WOODSPRING SUITES AT STATION 60 **SITE PLAN?**
PART OF THE SOUTHEAST QUARTER OF SECTION 32
TOWNSHIP 3 SOUTH, RANGE 66 WEST OF THE 6TH P.M.
CITY OF AURORA, ADAMS COUNTY, COLORADO

1st Review
Aurora Water
Jenny Wynn
jwynn@auroragov.org

SITE DEVELOPMENT PLAN
WOODSPRING SUITES AT STATION 60
COVER SHEET

1 FIRST FLOOR PLAN
 1/8" = 1'-0"

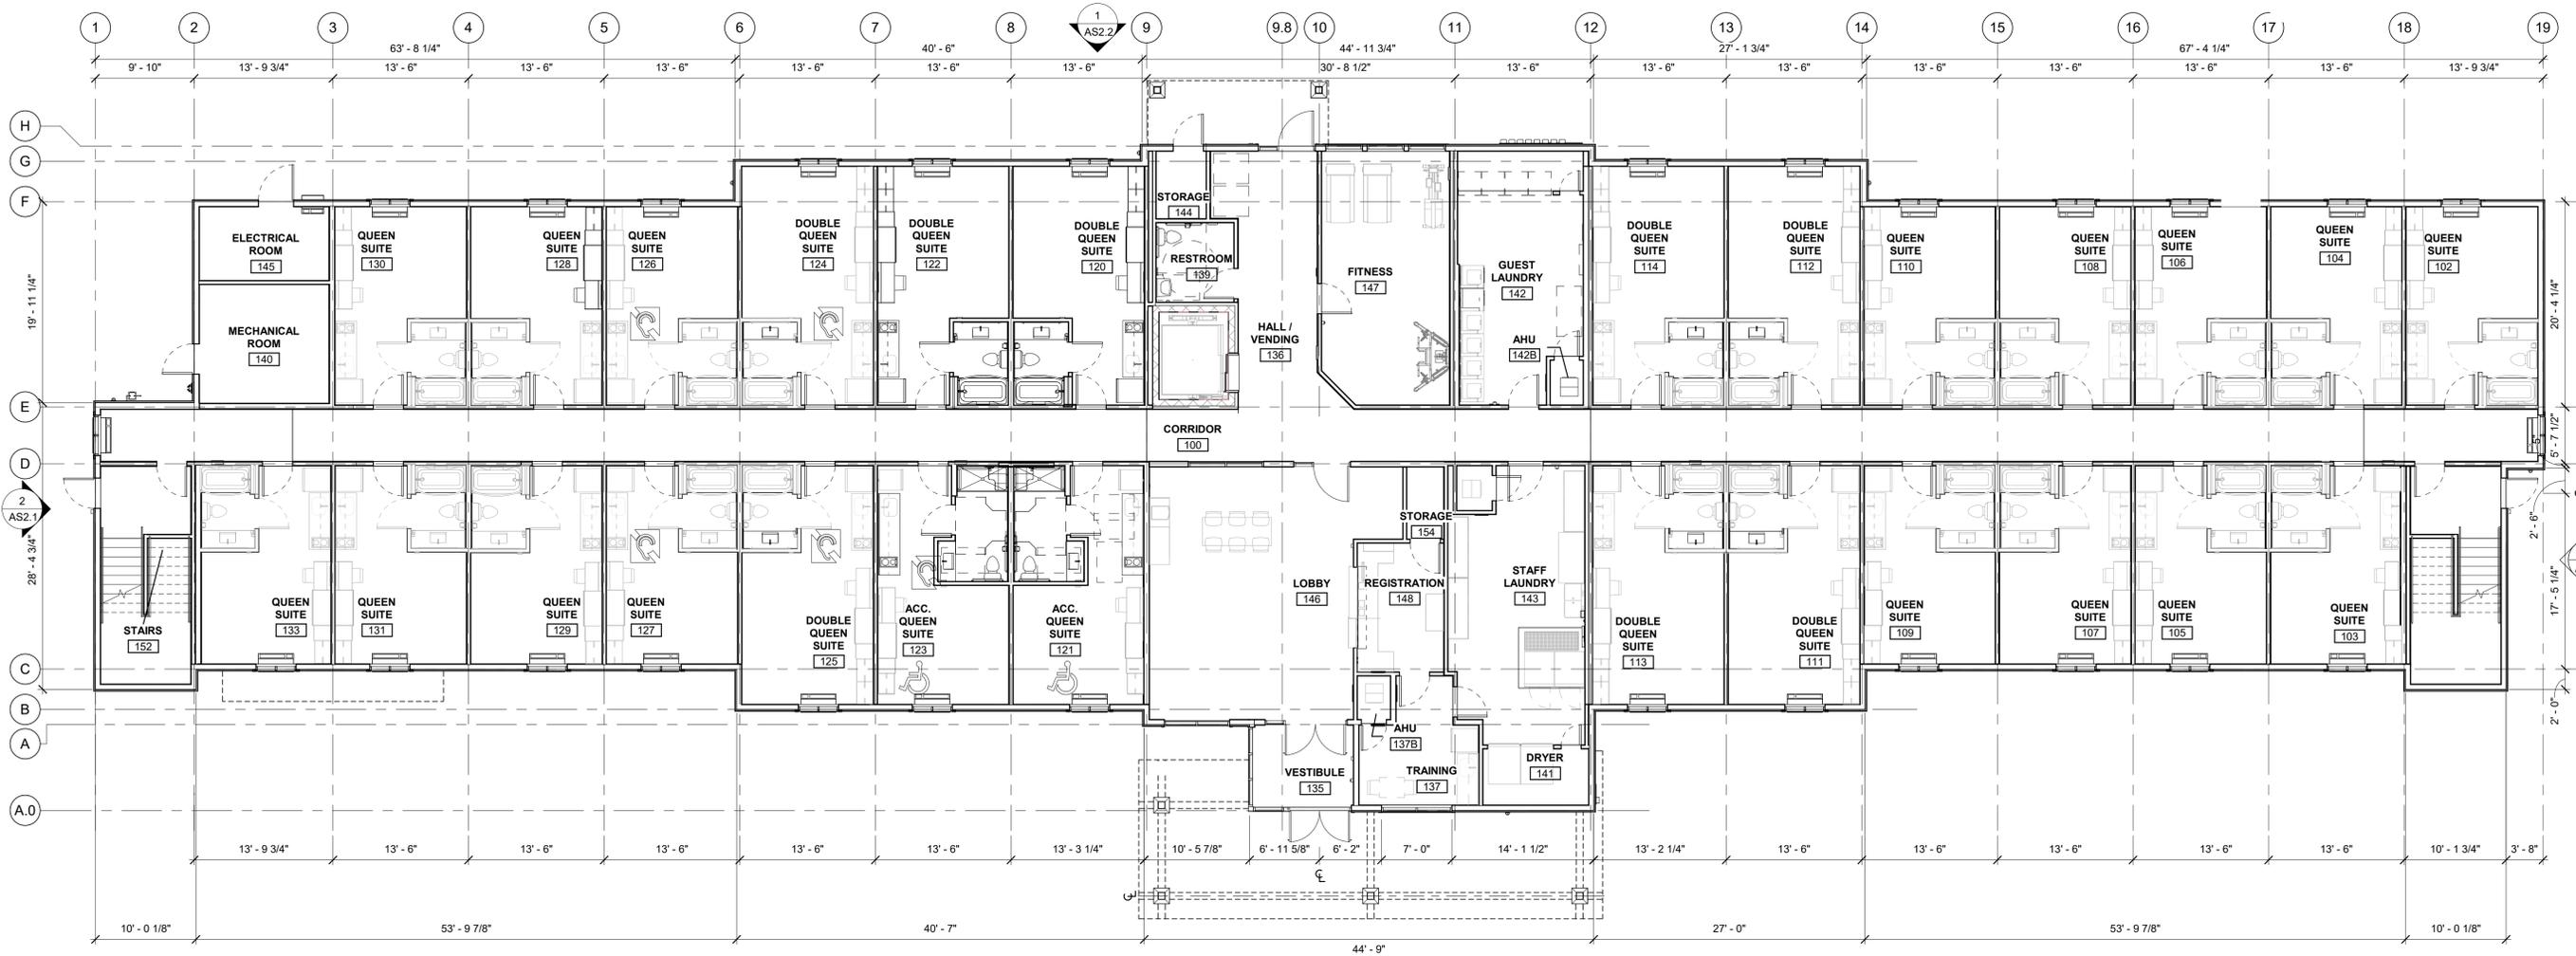
Floor plans are not necessary for site plan approval and will be reviewed by the building division upon submittal of building permit(s). Please remove these sheets.

Sheets have been removed

1 ROOF PLAN
 1/8" = 1'-0"

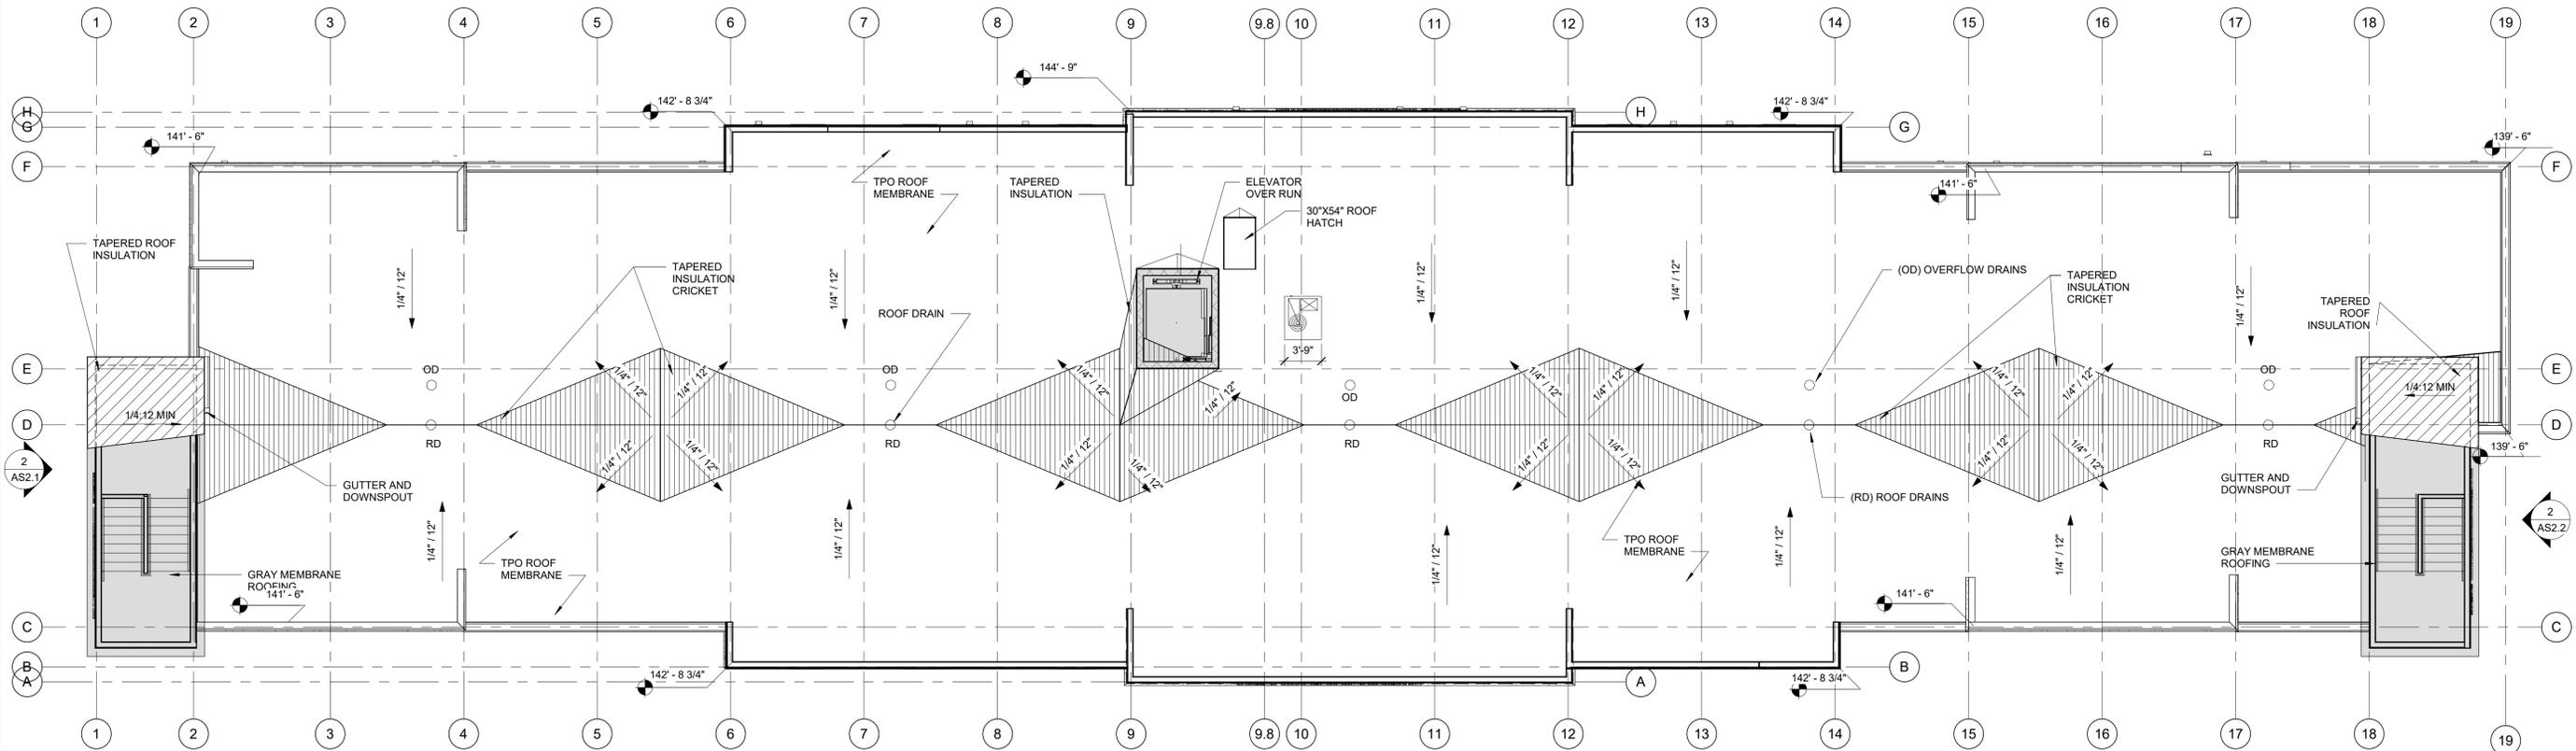
Roof plan is not required at this phase unless intended to show screening measures for rooftop equipment. If this is not the case please remove this sheet.

Roof plan have been kept in submittal
